SERVICE BULLETIN

ENGINE - FUEL AND CONTROL - FUEL AND CONTROL - REWORK THE SUPPORT ASSEMBLY ALIGNMENT HOLES - CATEGORY CODE 6 - MOD.ENG-73-0016

V2500-ENG-73-0016

Location of EEC Support Assemblies
Fig.1

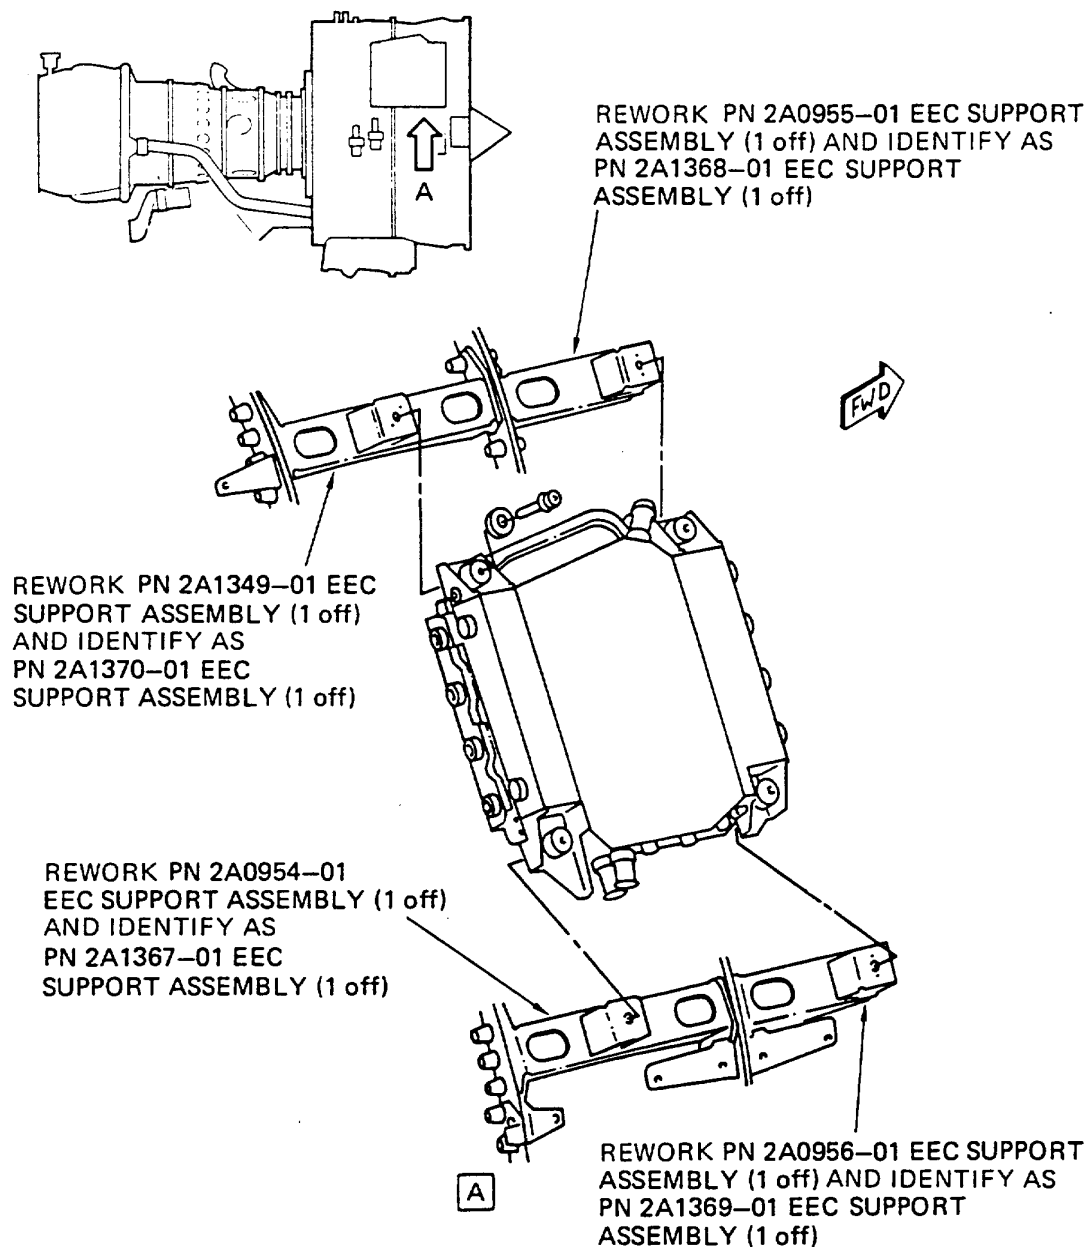
- (1) Install 2A1367-01 Support Assembly (1 off), 2A1368-01 Support Assembly (1 off), 2A1369-01 Support Assembly (1 off) and 2A1370-01 Support Assembly (1 off) by the approved procedures in Reference (2), Chapter/Section 72-00-32 Installation-01. See Figure 1.

Modification of 2A0954-01 of EEC Support Assembly
Fig.2

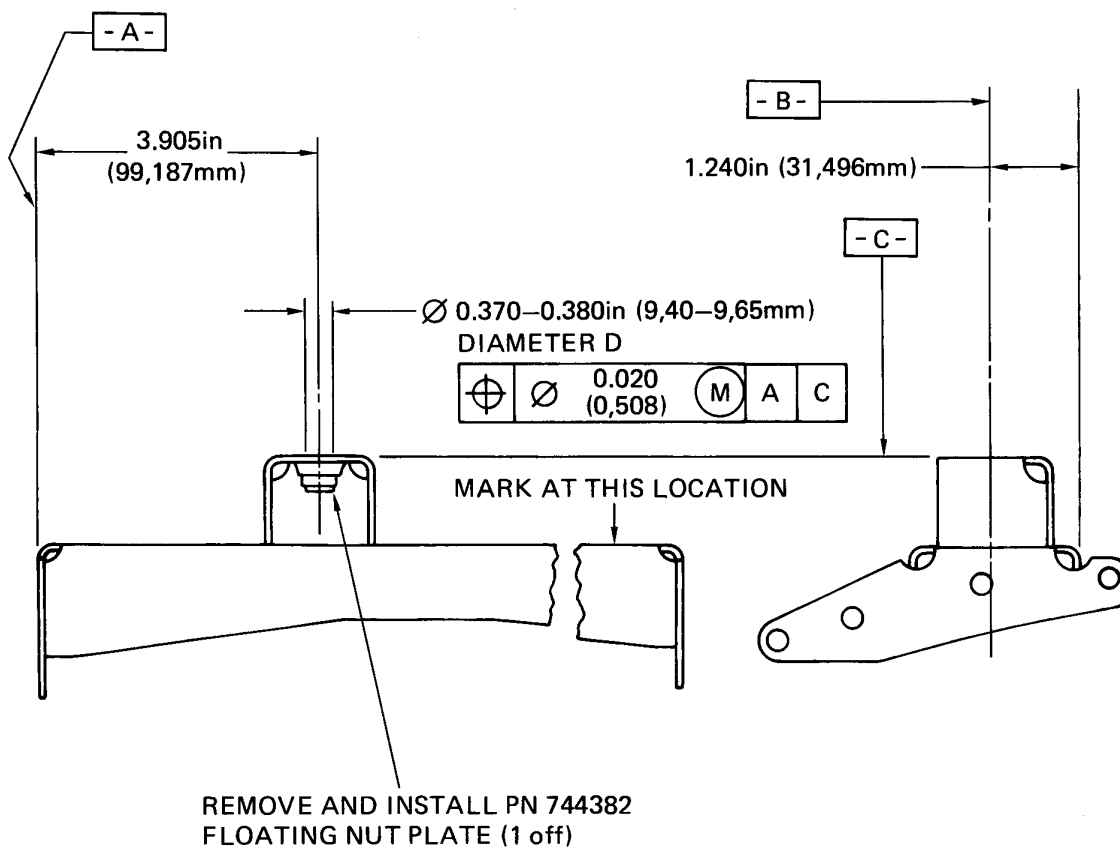
- (1) Do a modification on 2A0954-01 EEC Support Assembly (See Reference (1), Chapter/Section 73-22-34, Figure Item No.01-060) and identify as 2A1367-01 as follows:

Procedure	Supplementary Information	
(a) Remove the two Rivets that hold the Floating Nut Plate Lugs on the Support Assembly	Refer to Figure 2. Refer to the approved procedure in Reference (4), Repair-006 VRS3349 TASK 73-22-34-300-006.	
(b) Set-up and machine the support to Diameter D given in the Figure.	Refer to Figure 2, requirements.	
(c) Install the new 744382 Floating Nut Plate (1 off) on the Support Assembly with AS3228-102 Rivets (2 off).	Refer to Figure 2. Refer to the approved procedure in Reference (4), Repair-006 VRS3349 TASK 73-22-34-300-006.	
(d) Mark the new part number adjacent to the old part number. Use the vibration peen method.	Old Part Number 2A0954-01	New Part Number 2A1367-01
	Refer to Figure 2, requirements. Refer to the approved procedure in Reference (3), Control No./TASK No.70-09-00-400-501.

Modification of 2A955-01 of EEC Support Assembly
Fig.3

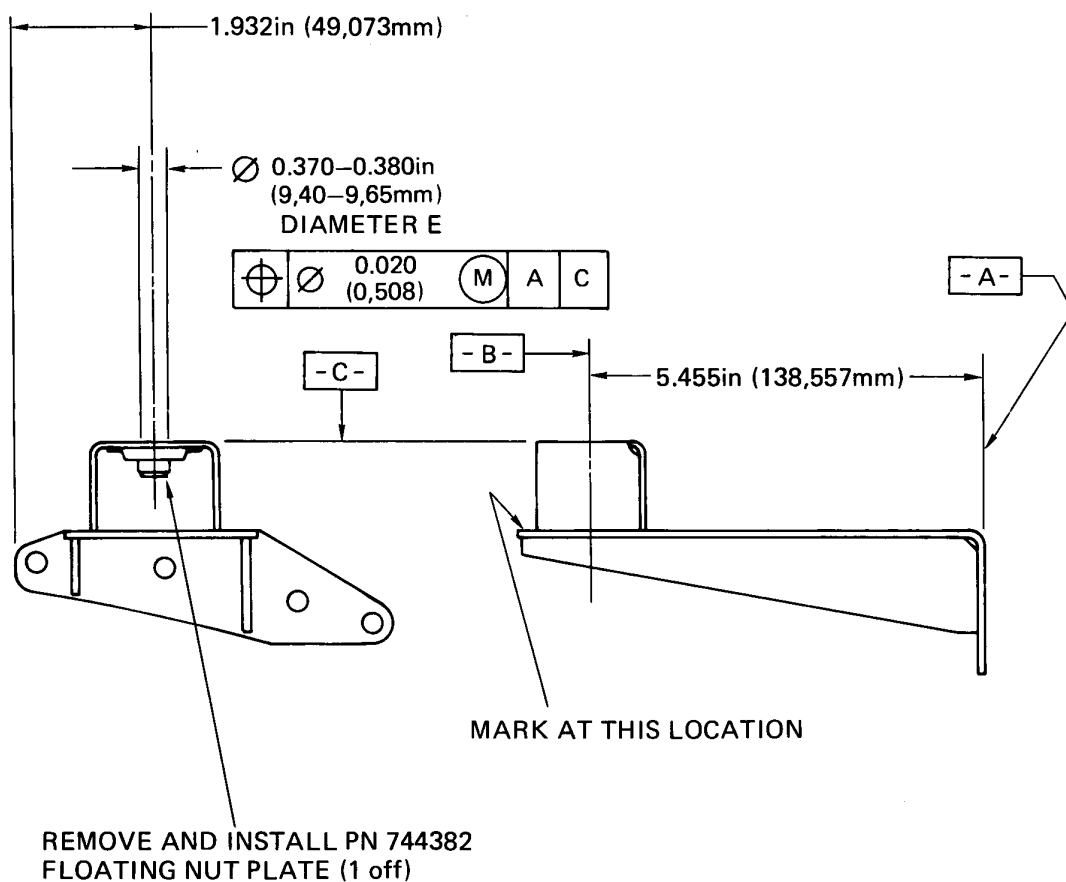
- (2) Do a modification on 2A0955-01 EEC Support Assembly (See Reference (1), Chapter/Section 73-22-34, Figure Item No.01-120) and identify as 2A1368-01 as follows:

(a) Remove the two Rivets that hold the Floating Nut Plate Lugs on the Support Assembly.	Refer to Figure 3. Refer to the approved procedure in Reference (4), Repair-007 VRS3350 TASK 73-22-34-300-007.	
(b) Set-up and machine the Support to Diameter E given in the Figure.	Refer to Figure 3, requirements.

- (c) Install the new 744382 Floating Nut Plate (1 off) on the Support Assembly with AS3230-102 Rivets (2 off).
- Refer to Figure 3. Refer to the approved procedure in Reference (4), Repair-007 VRS3350 TASK 73-22-34-300-007.

- (d) Mark the new part number adjacent to the old part number. Use the vibration peen method.
- | Old Part Number | New Part Number |

Modification of 2A956-01 of EEC Support Assembly
Fig.4

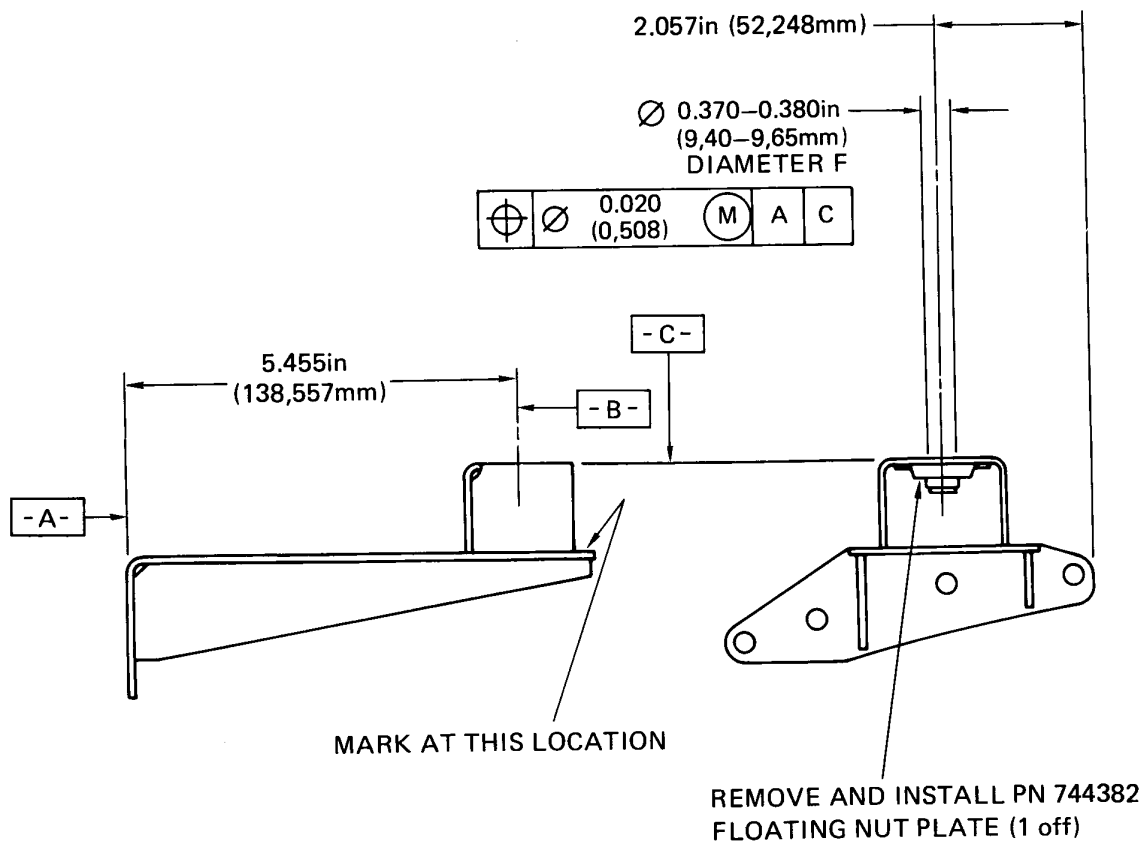
- Refer to Figure 3, requirements. Refer to the approved procedure in Reference (3), Control No./TASK No.70-09-00-400-501.
- (3) Do a modification on 2A0956-01 EEC Support Assembly (See Reference (1), Chapter/Section 73-22-34, Figure Item No.01-180) and identify as 2A1369-01 as follows:

- (a) Remove the two Rivets that hold the Floating Nut Plate Lugs on the Support Assembly.
- Refer to Figure 4. Refer to the approved procedure in Reference (4), Repair-008 VRS3351 TASK 73-22-34-300-008.

- (b) Set-up and machine the Support to Diameter F given in the Figure.
- Refer to Figure 4, requirements.
- (c) Install the new 744382 Floating Nut Plate (1 off) on the Support Assembly with AS3230-102 Rivets (2 off).

- Refer to Figure 4. Refer to the approved procedure in Reference (4), Repair-008 VRS3351 TASK 73-22-34-300-008.
- (d) Mark the new part number adjacent to the old part number. Use the vibration peen method.

Modification of 2A1349-01 of EEC Support Assembly
Fig.5

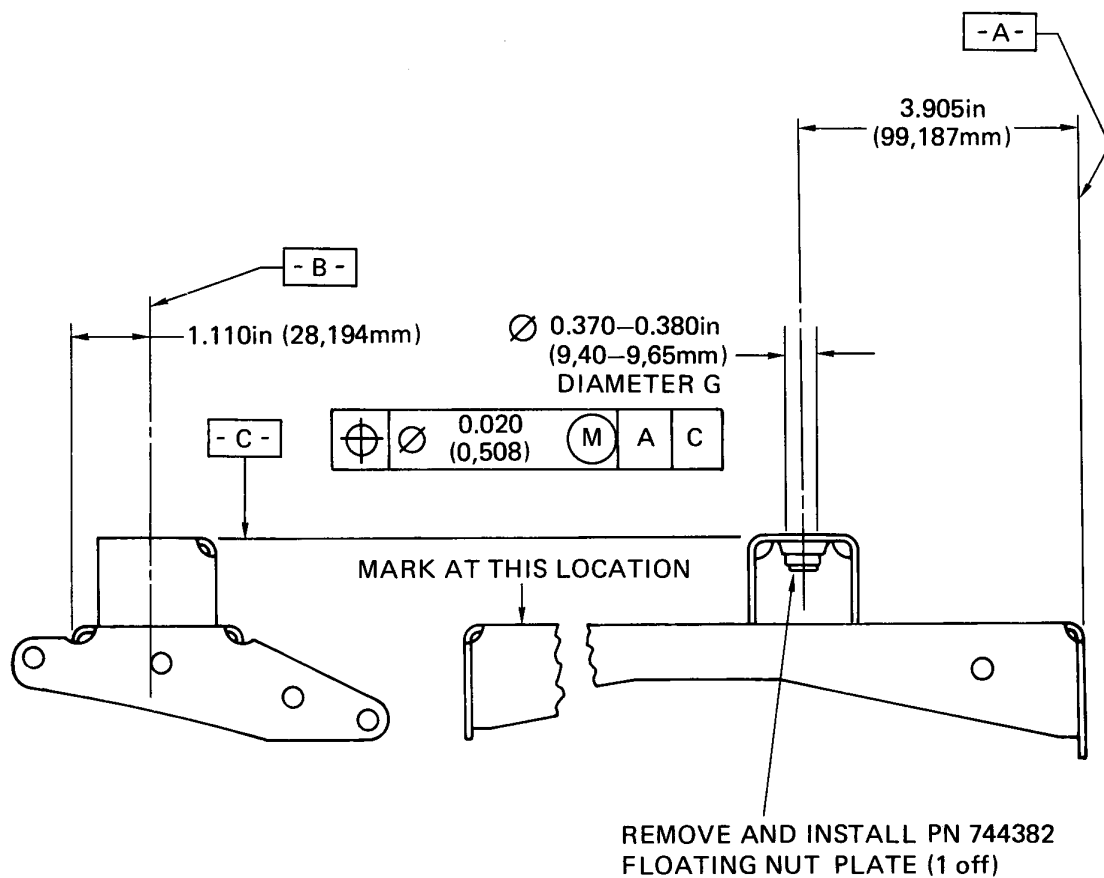
- Refer to Figure 4, requirements. Refer to the approved procedure in Reference (3), Control No./TASK no.70-09-00-400-501.
- (4) Do a modification on 2A1349-01 EEC Support Assembly (See Reference (1), Chapter/Section 73-22-34, Figure Item No.01-010) and identify as 2A1370-01 as follows:

- | | | | | | |
|---|--|-----------------|-----------------|-----------|-----------|
| (a) Remove the two Rivets that hold the Floating Nut Plate Lugs on the Support Assembly. | Refer to Figure 5. Refer to the approved procedure in Reference (4), Repair-005 VRS3348 TASK 73-22-34-300-005. | | | | |
| (b) Set-up and machine the Support to Diameter G given in the Figure. | Refer to Figure 5, requirements. | | | | |
| (c) Install the new 744382 Floating Nut Plate (1 off) on the Support Assembly with AS3228-102 Rivets (2 off). | Refer to Figure 5. Refer to the approved procedure in Reference (4), Repair-005 VRS3348 TASK 73-22-34-300-005. | | | | |
| (d) Mark the new part number adjacent to the old part number. Use the vibration peen method. | <table border="0"> <tbody> <tr> <td>Old Part Number</td> <td>New Part Number</td> </tr> <tr> <td>2A1349-01</td> <td>2A1370-01</td> </tr> </tbody> </table> <p>Refer to Figure 5, requirements. Refer to the approved procedure in Reference (3), Control No./TASK No.70-09-00-400-501.</p> | Old Part Number | New Part Number | 2A1349-01 | 2A1370-01 |
| Old Part Number | New Part Number | | | | |
| 2A1349-01 | 2A1370-01 | | | | |
